# Ventura County Community College District

DATE: April 30, 2024  
TO: All Bidders  
FROM: David Cienfuegos, Purchasing Specialist  
SUBJECT: Addendum 1 – Bid 670, Oxnard College LA-7 Classroom Renovation

**OXNARD COLLEGE STEM CLASSROOM ALTERATION**  
4000 S ROSE AVE. OXNARD, CA 93033  
**ROOF PLAN & SECTIONS**

**3 SUSPENDED CHANNEL FRAMING DETAIL**  
A-104 | A-104 SCALE: 3/4" = 1'-0"

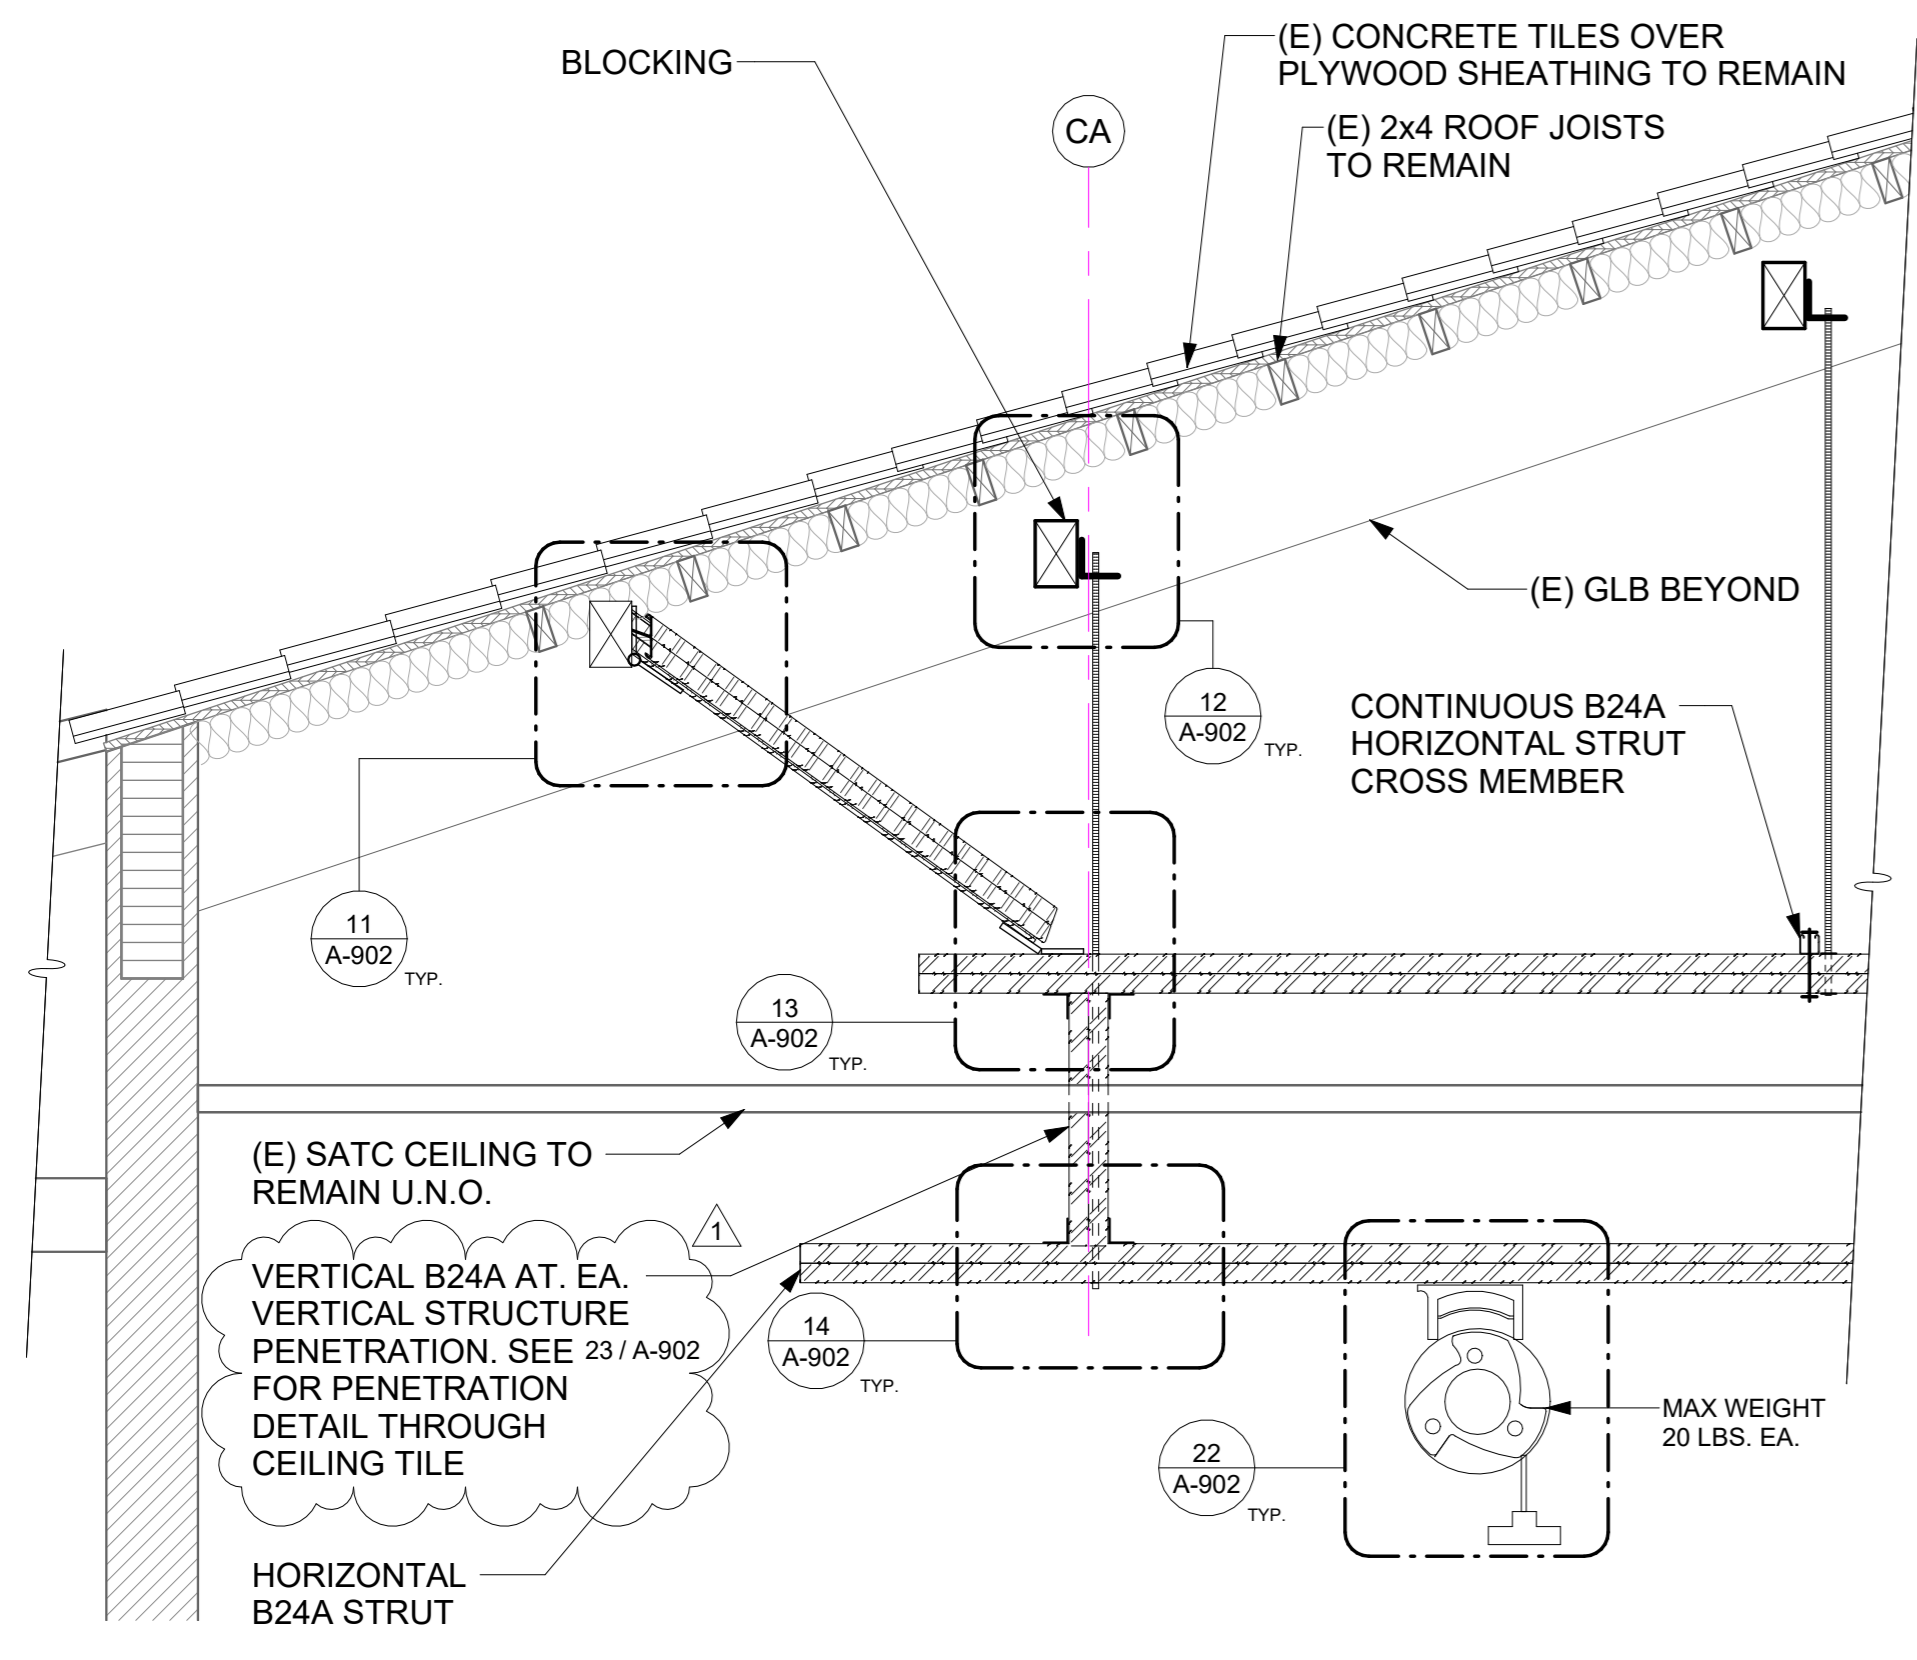
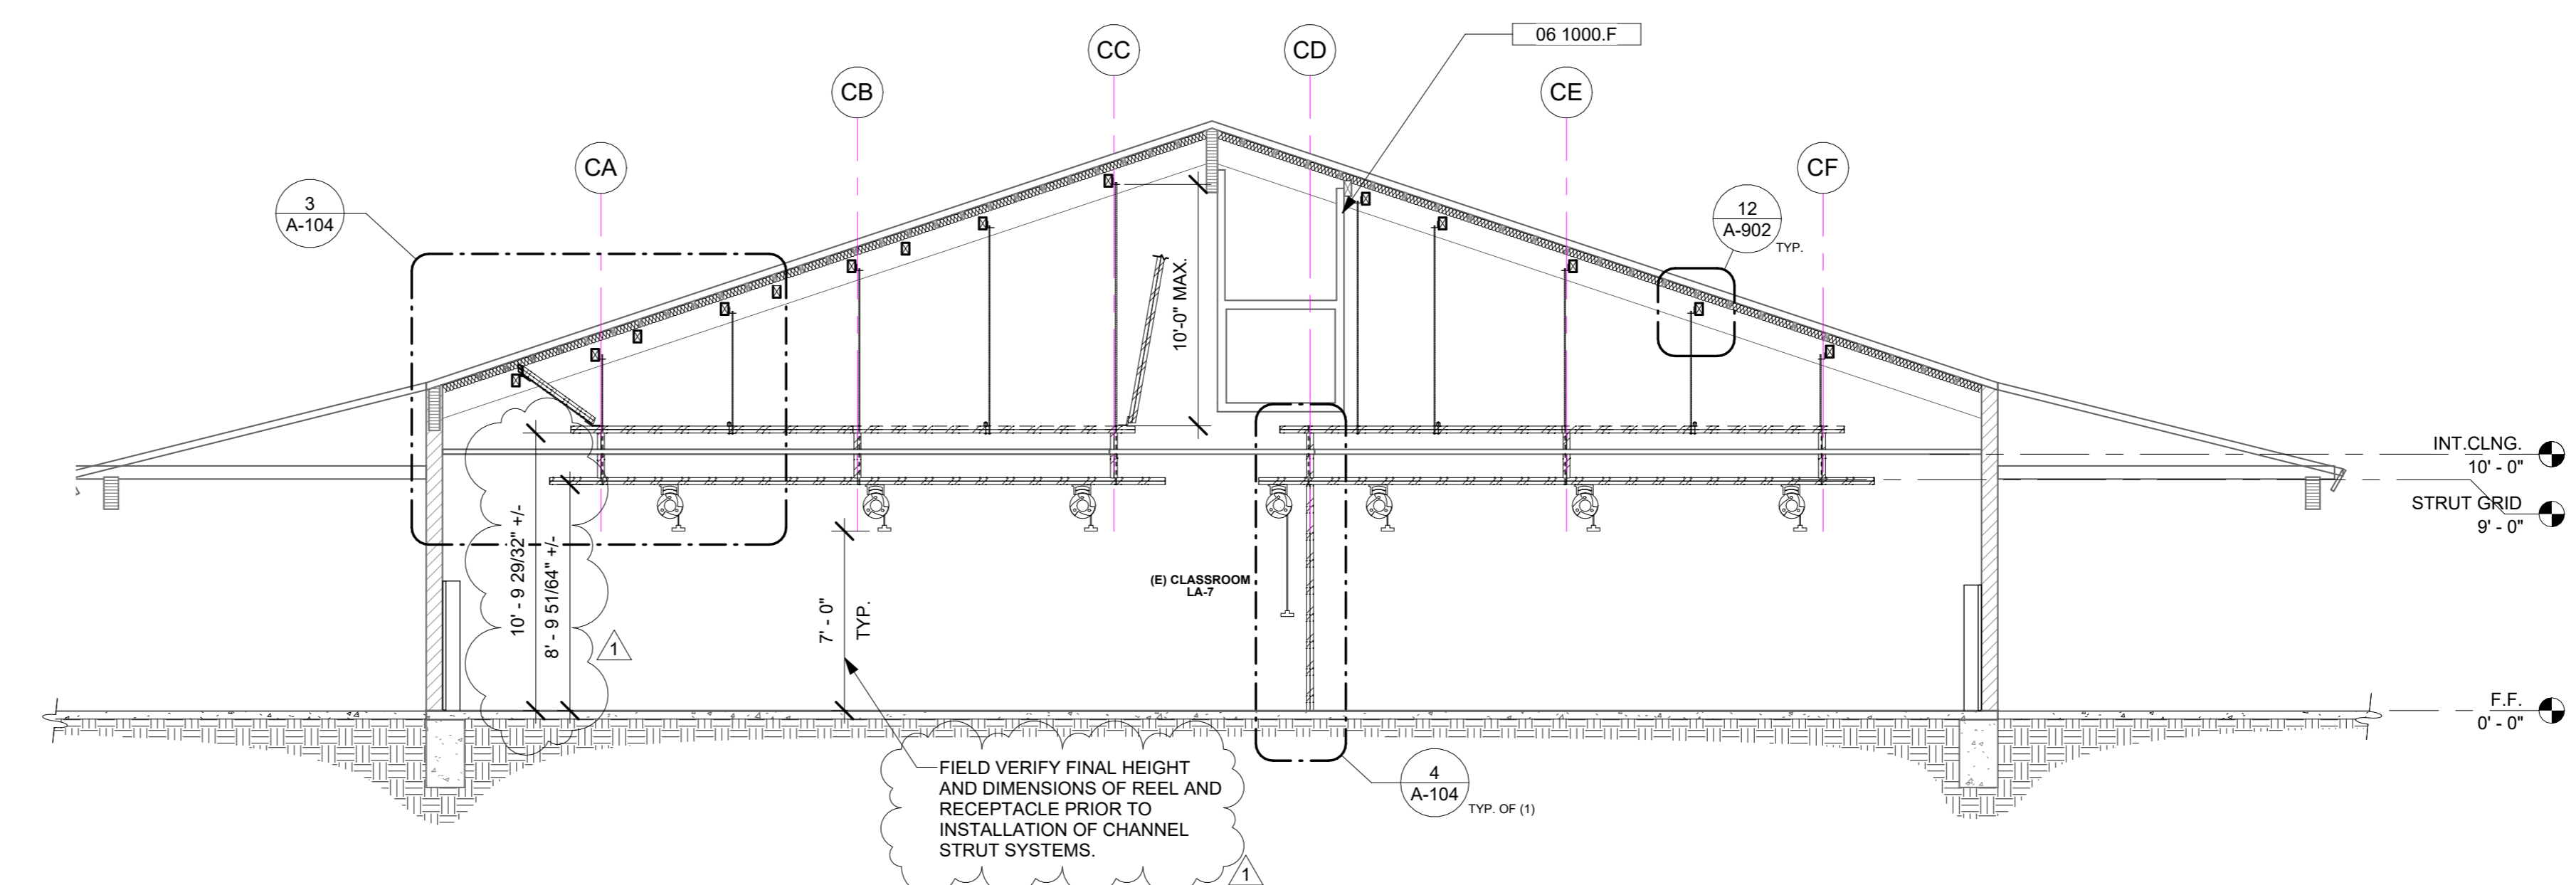
- A. Added notes to all drawing views on sheet

**44 TENSILE TESTER EQUIPMENT TABLE**  
SCALE: 1 1/2" = 1'-0"

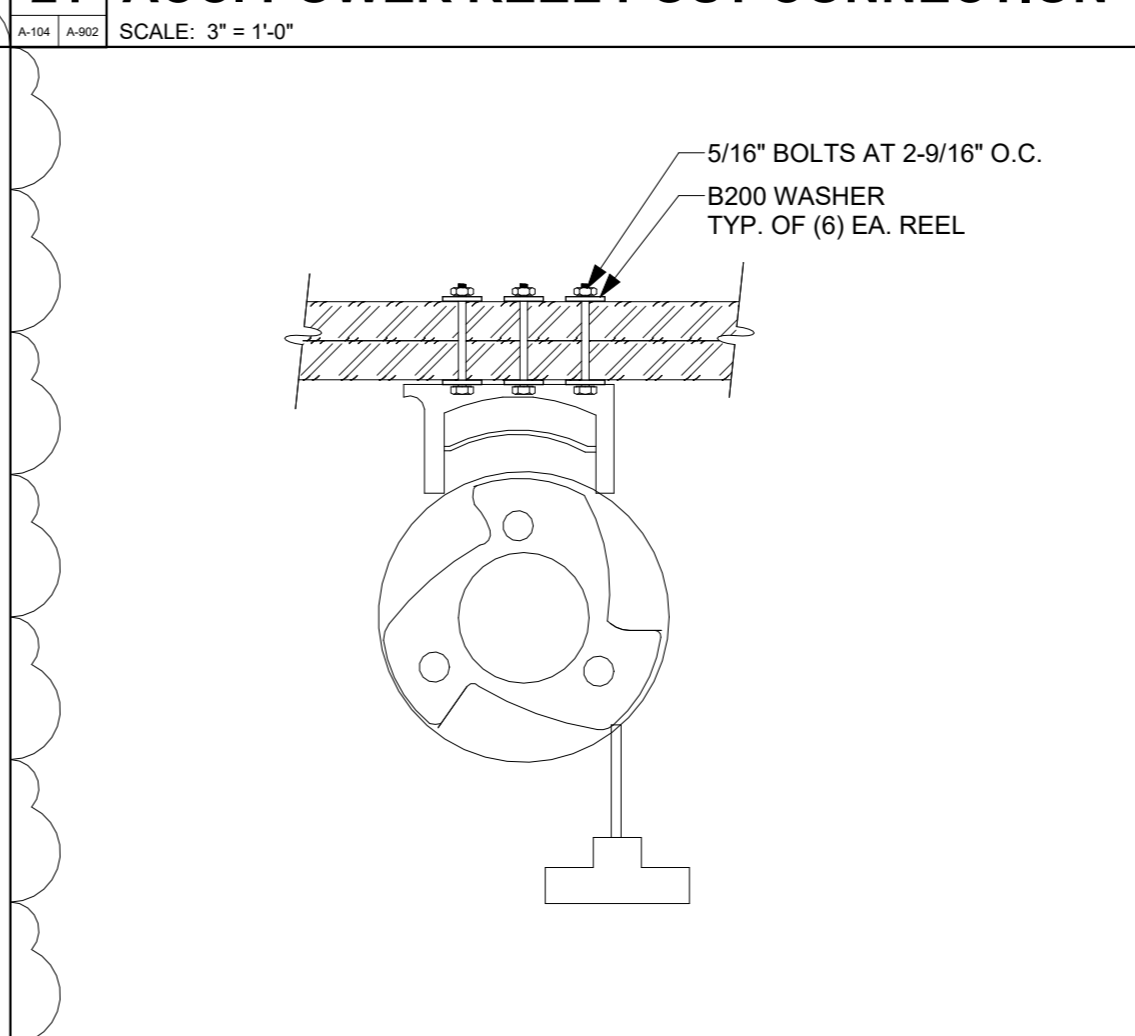
- A. Added detail drawing 44
- B. Revised detail drawing 13 to show missing bolts
- C. Added notes to detail drawings 23 and 24
